**ALERT SERVICE BULLETIN**

NO. 407-99-31  
DATE 09-10-99  
PAGE 1 of 31

**MODELS AFFECTED:** 407

**SUBJECT:** FADEC – DIRECT REVERSION TO MANUAL (DRTM) SYSTEM, UPGRADE TO.

Figure 1 FADEC Removal of Existing Cover Assembly/Installation of New Switch Guard

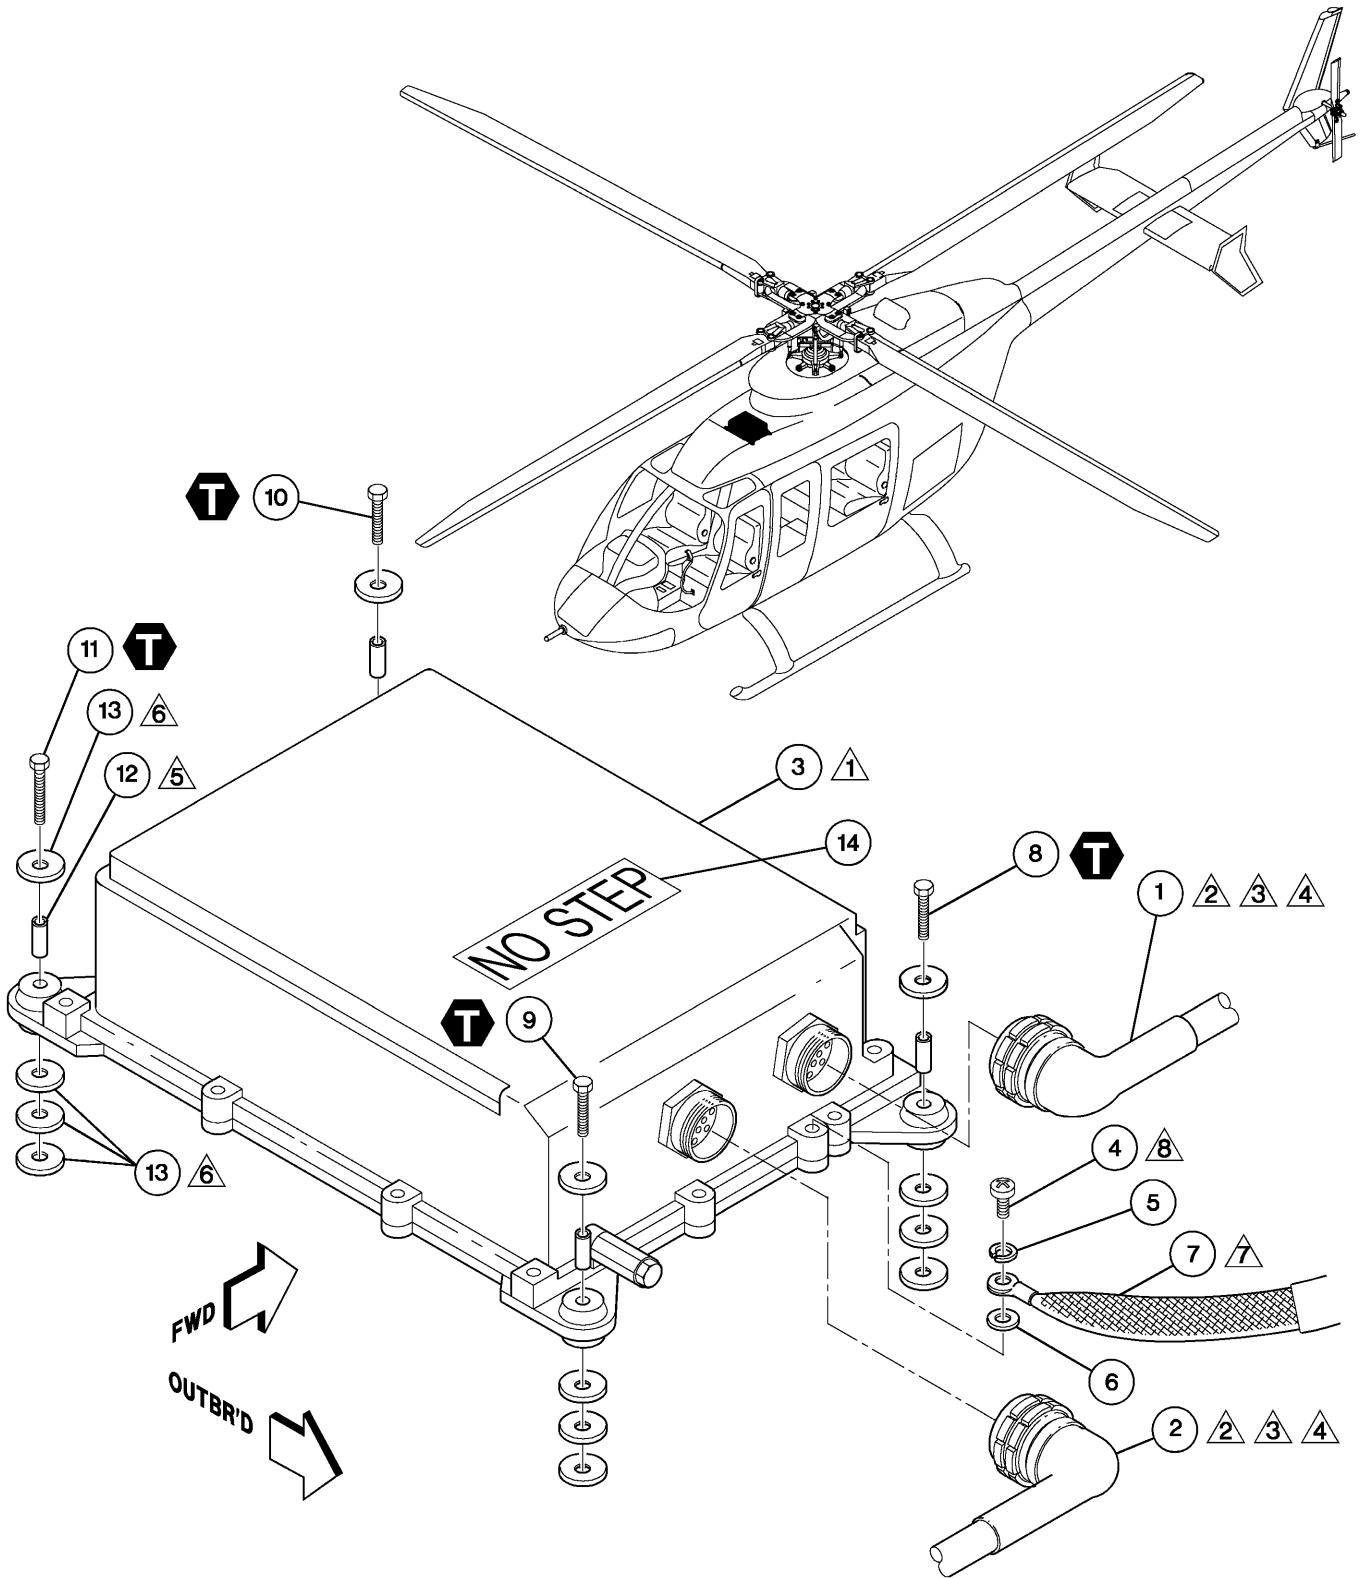
8. To install the new switch guard (407-030-008-101), put the switch wires through slot in guard. With the switch housing positioned with the (TOP) in the “up” position, put the guard, with the slot in the “up” position on the switch housing.

9. With switch housing positioned with (TOP) in the “up” position and with the slot in the new guard in the “up” position, push the switch housing into the instrument panel.

10. Get access to the back of the instrument panel and put the panel spacer and the mounting sleeve on the switch housing. Install the mounting sleeve as shown in Figure 1.

11. Hold the switch and mounting sleeve in position and turn the locking screws, inside the switch housing, clockwise until the mounting cams contact the mounting sleeve and the switch is correctly attached. Do not over-tighten the locking screws.

12. Install the push-button assembly, with slot in the “up” position, and carefully put it into the switch until it snaps into place. Cycle the push-button and make sure it latches in the inner position and unlatches to the outer position.

**Figure 3. Collective Throttle Modification (Sheet 1)**

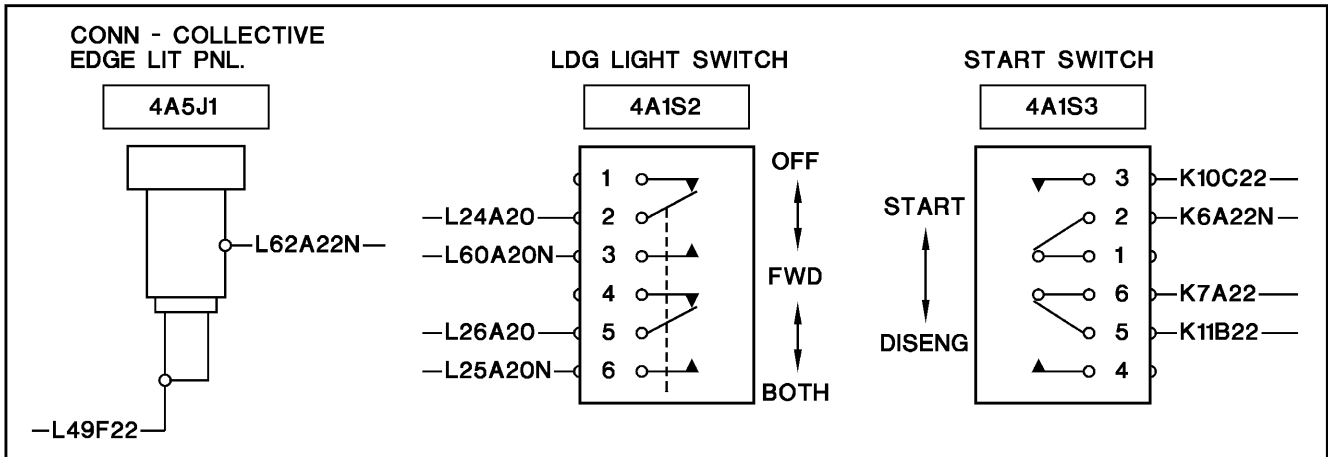
1. Disconnect the helicopter electrical power.
2. Remove the screws (1, Figure 3, Sheet 1) and the collective switch box lit panel assembly (2).
3. Remove screws (3) and the cover (4). Keep the hardware for installation.

6. Remove the throttle friction assembly (5, 6, and 7, Figure 3, Sheet 1 and 3) from the collective switch box. Keep the hardware for the installation (i.e. 1-setscrew, 7-spring washers, 1-plug).
7. Remove wiring harness clamp and its hardware (8, 9, 10, 11, and 12, Figure 3) from the collective switch box. Keep the hardware for the installation.

18. Install the new switch box assembly (24) on the collective tube assembly (20). Prior to sliding the switch box fully onto the collective tube, apply a very light layer of unreduced primer (C-204) to the inside diameter of the collective switch box mounting bore (Figure 3, Sheet 1). Turn the switch box assembly (24) so the mounting holes for the pins (13) align with the collective tube assembly (20).

19. Put a support below the collective and switch box assembly and install the two new pins (13, Figure 3, Sheet 1) with pin punch and hammer.
20. Install the clamp and hardware for the wiring harness (8, 9, 10, 11, and 12, Figure 3, Sheet 1) in the collective switch box.

**Figure 3. Collective Throttle Modification (Sheet 2)**

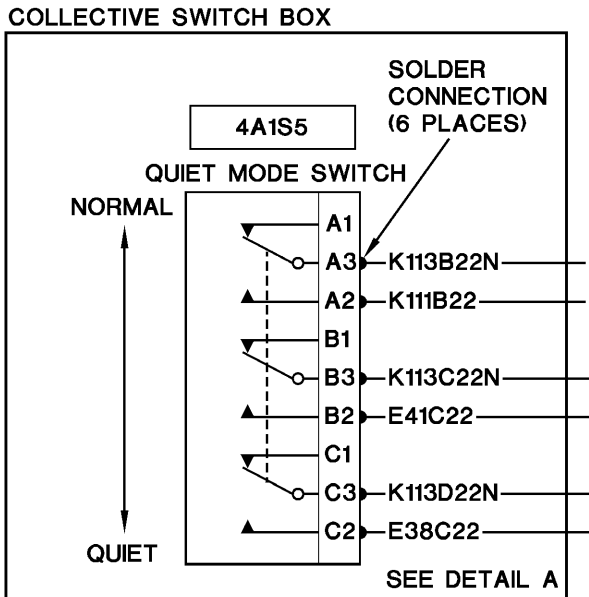
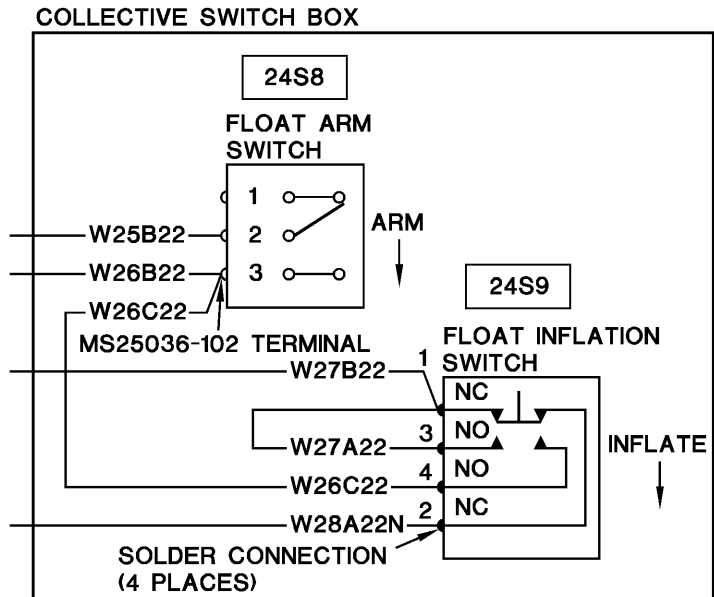
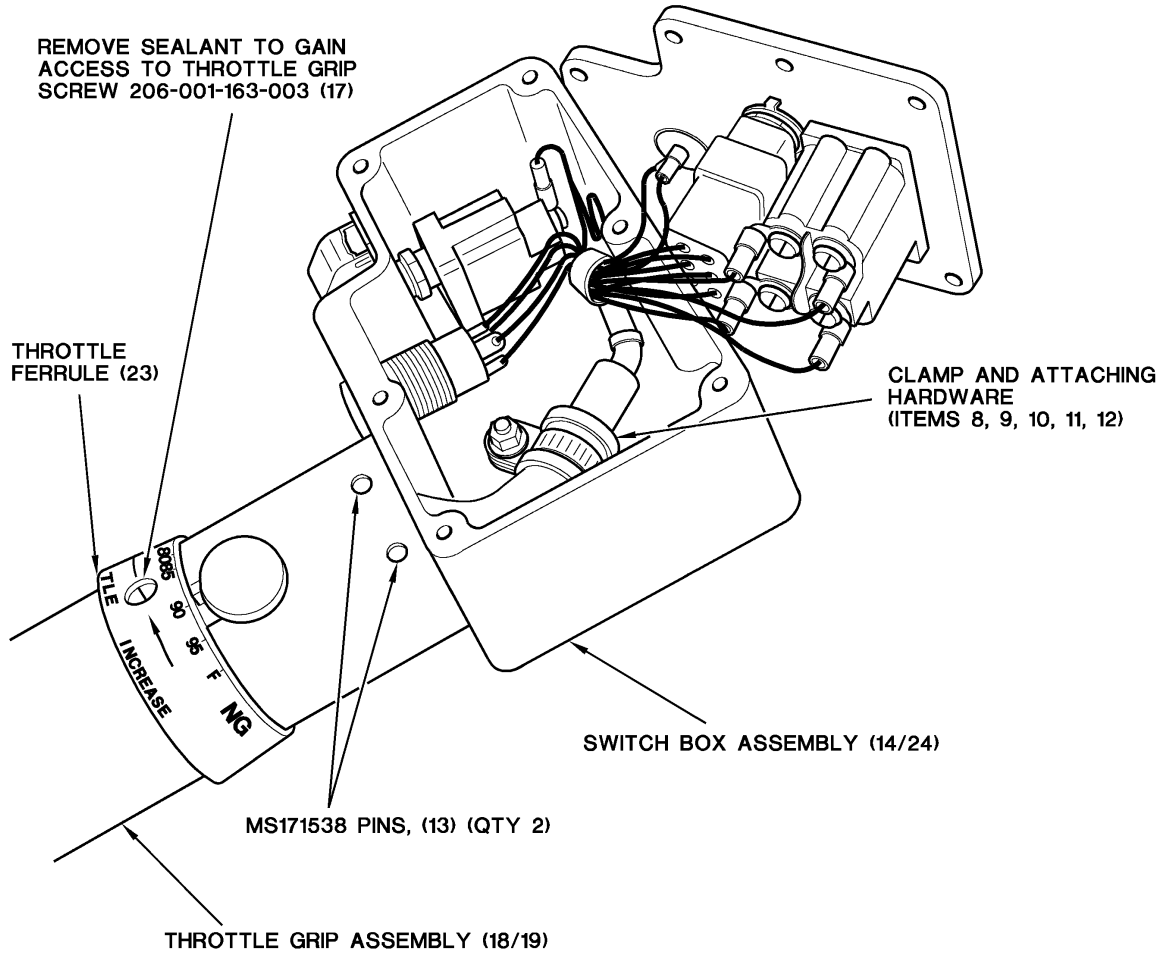
MAKE SURE ALL SWITCH WIRING IS CORRECTLY INSTALLED. DO A CHECK TO MAKE SURE THE WIRING IS INSTALLED CORRECTLY AS SPECIFIED IN Figure 3, Sheet 2. REMOVE ALL THE TAPE THAT YOU INSTALLED TO IDENTIFY THE WIRE NUMBERS.

22. Install the wiring to the Lighting connector and the Start and Landing Light switches. Wires for Landing Light switch can be inserted with finger pressure. Refer to Figure 3, Sheet 2, for the correct wiring installation.

23. If applicable, attach wiring to the Quiet Mode Switch. Refer to Figure 3, Sheet 2, for the correct wiring installation. For solder connections, install insul tubing P/N 130-005-6K2 as necessary, and utilize solder (EC-041). Refer to Bell Helicopter Electrical Standard Practices Manual BHT-ELEC-SPM for soldering procedures. For more specific information on the Quiet Mode switch and wiring procedures, refer to Installation Instruction BHT-407-II-21.

**Figure 3. Collective Throttle Modification (Sheet 5)**

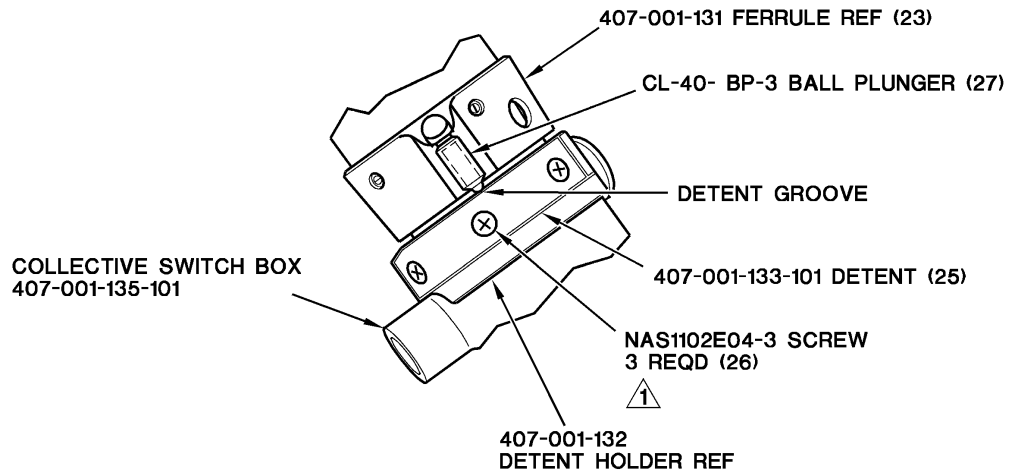
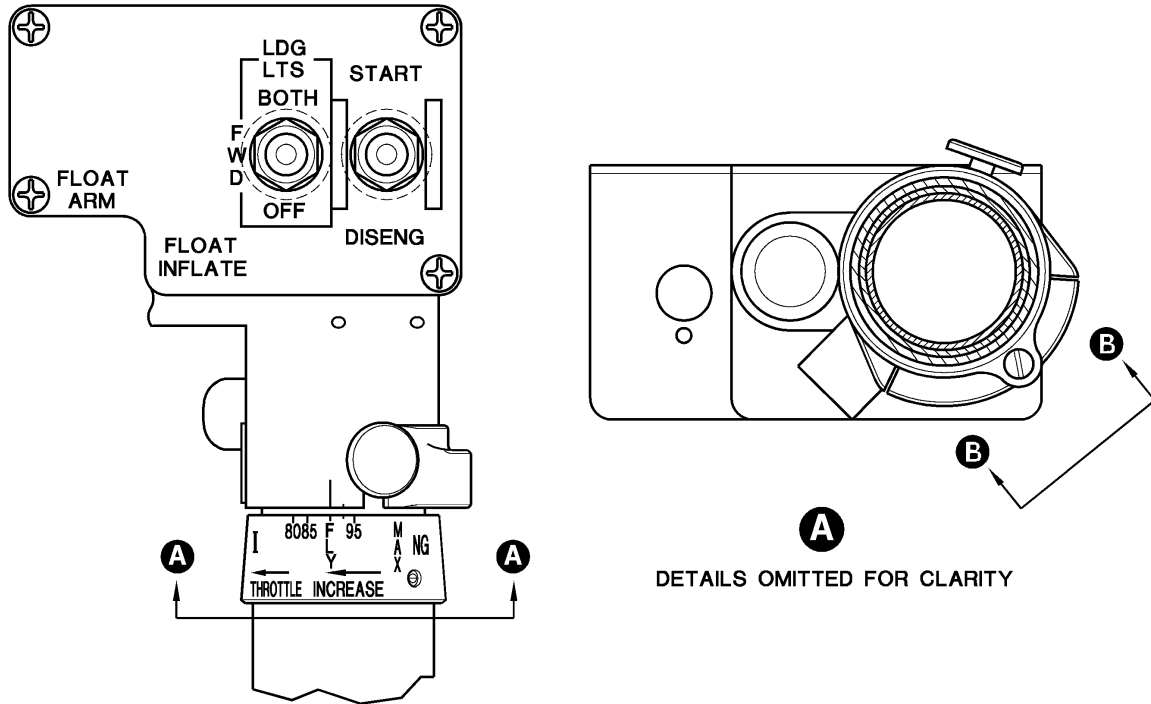
12. Put the new throttle grip assembly (19, Figure 3) on the collective tube assembly (20). (Refer to Figure 3, Sheet 5 for more information.)
13. Remove the four screws (22, Figure 3, Sheet 5) from the ferrule/bezel (23). Referring to Figure 3, Sheet 5, Detail A, remove the ferrule/bezel (23) until you can adjust and confirm alignment between all four setscrew positions and their associated recessed areas on the throttle grip assembly. Apply a piece of tape over one of the ferrule/bezel set screw positions and apply a piece of tape adjacent to it on the cork portion of the throttle grip. Using a pen line, match mark the center of the set screw to the center of its associated recessed area on the throttle grip. Slide the ferrule/bezel into position on the throttle grip.

14. Turn the ferrule until the access holes, for the screw (17), in the ferrule and the throttle grip are aligned. Keeping the alignment of the access holes, turn the ferrule and throttle grip until you have alignment with the threaded support hole in the throttle tube assembly (21). Install and tighten the screw (17). (Refer to Figure 3, Sheet 5 for more information.)

15. Using the pen line match mark reference from Step 13, align the ferrule/bezel setscrew positions with the recessed areas in throttle grip (Figure 3, Sheet 5, Detail A). Lightly install the setscrews to prevent movement of the ferrule (23) on throttle grip (19). Remove tape from ferrule and throttle.

**Figure 3. Collective Throttle Modification (Sheet 6)**

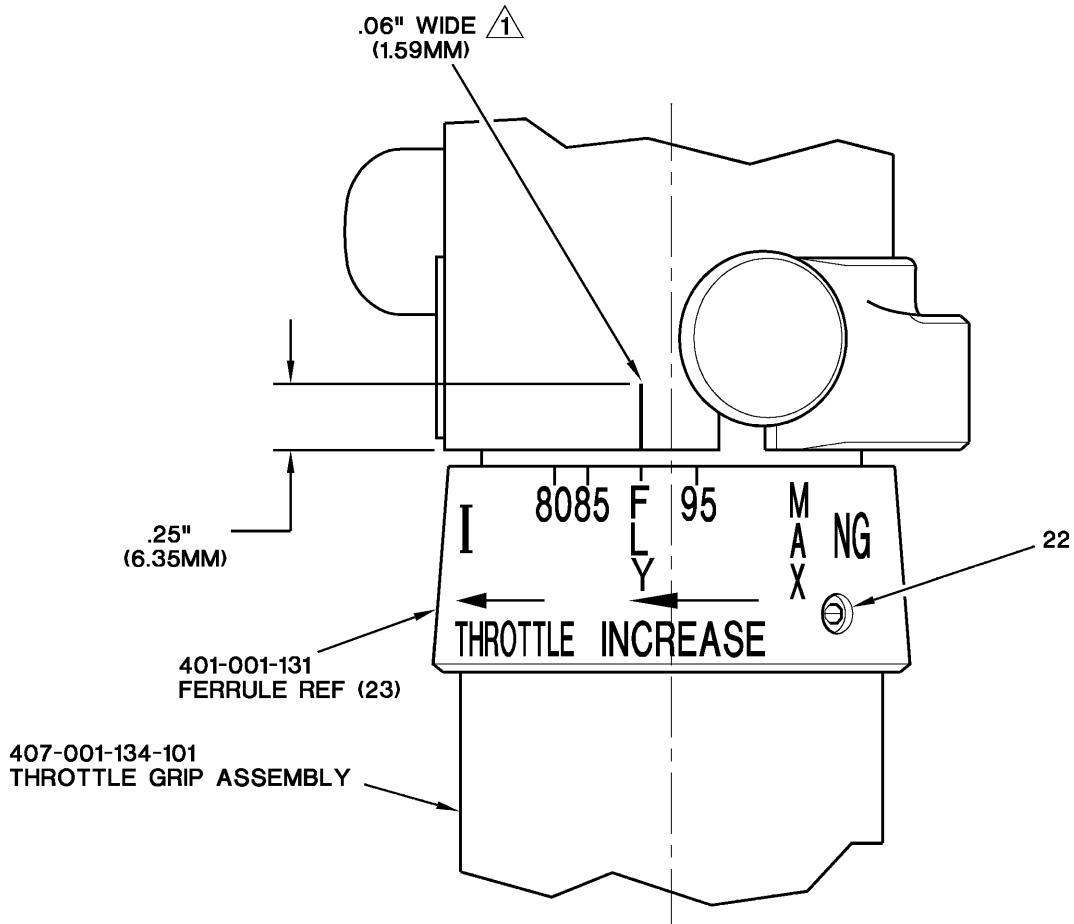
17. Use the three screws (26), wet with sealant (C-392), to install the detent (25, Figure 3, Sheet 6, Detail B) on the collective switch box detent holder.

29. Install the ball plunger (27, Figure 3, Sheet 6) into the ferrule (23).
30. To adjust the ball plunger to get a peak rotational value of between 4 to 5 pounds (1.8 to 2.3 Kg) in excess of throttle friction adjustment in Step 28 when the ball plunger rides through the detent groove, do the procedure that follows:

- c. Pull the fish scale to turn the throttle in and out of the groove. Adjust ball plunger (27) to make sure the fish scale value is 14 to 15 +/-0.5 pounds (6.3 to 6.8 +/-0.23 Kg) when the plunger is pulled through the detent in either direction.
